PARTS & SERVICE NEWS

REF NO.	AT01030
DATE	Apr. 11, 2001
(C)	Page 1 of 3

SUBJECT: INTRODUCTION OF IMPROVED HOSE CLAMP ON HD465-5/HD605-5

APPLICATION: HD465-5 Dump Trucks, Serial Nos. 4407 thru 4886
HD605-5 Dump Trucks, Serial Nos. 1001 thru 1130

Fig. 1

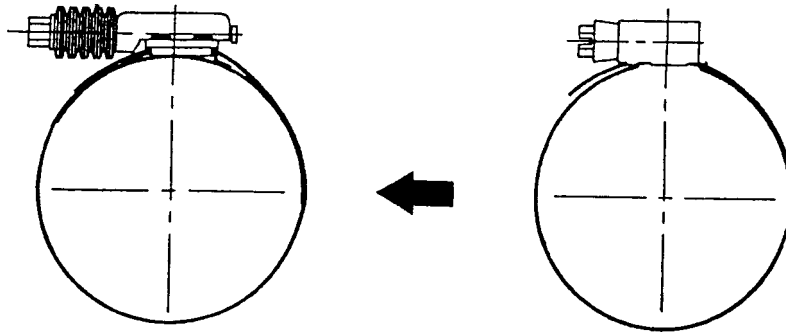
The current high torque type clamps (KES D07289) made by Breeze are being changed to Breeze's constant torque type clamps (KES D07299) with which the tightening torque level is less apt to change.

Fig. 2

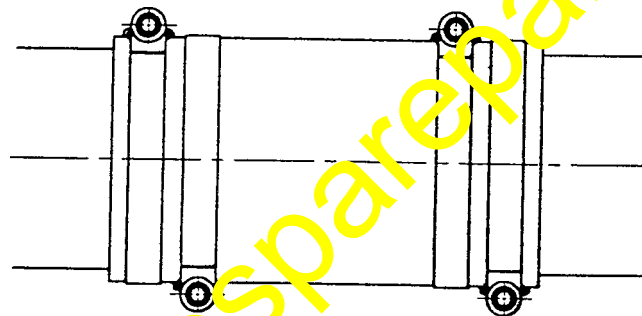
(1) The positioning of the clamp pair should be deviated by 130° .

Fig. 3

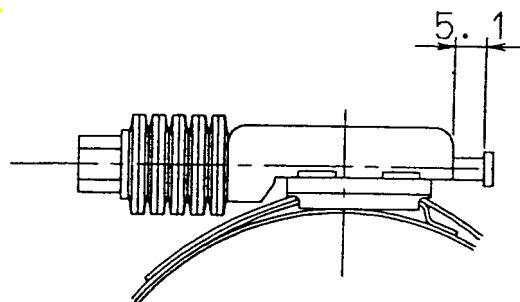
(2) Tighten the clamps (07299-00120) at a tightening torque of 9.8 ± 0.5 Nm $\{1.0 \pm 0.05$ kgm $\}$.

When the clamps are tightened at the tightening torque of 9.8 Nm $\{1.0$ kgm $\}$, the projection of the upper end of the screw will be 5.1 mm.

Fig. 4

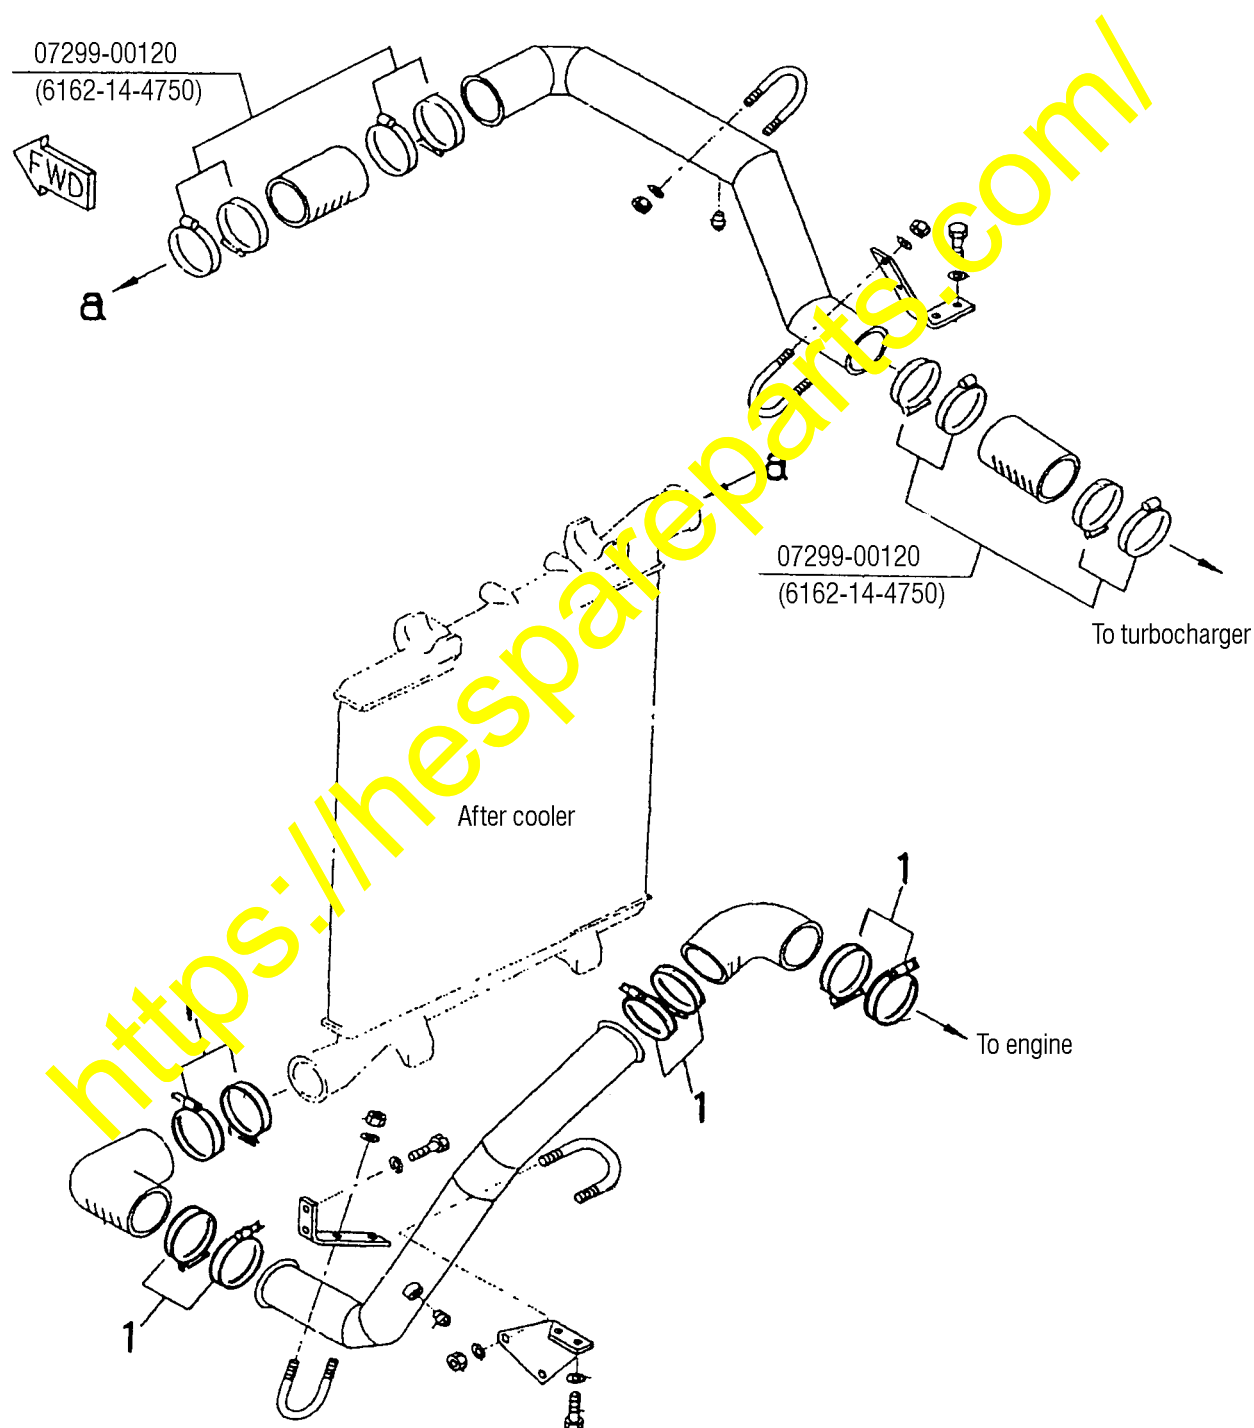
The number being used in the illustration given below corresponds to the item number in the list of necessary parts for this modification.

The clamps with the Part No. 6162-14-4750 are identical to the clamps with the Part No. 07299-00120.

Since the part number conforming to the KES standard has been registered this time, we unified the part number for the clamps to the one conforming to the KES standard.
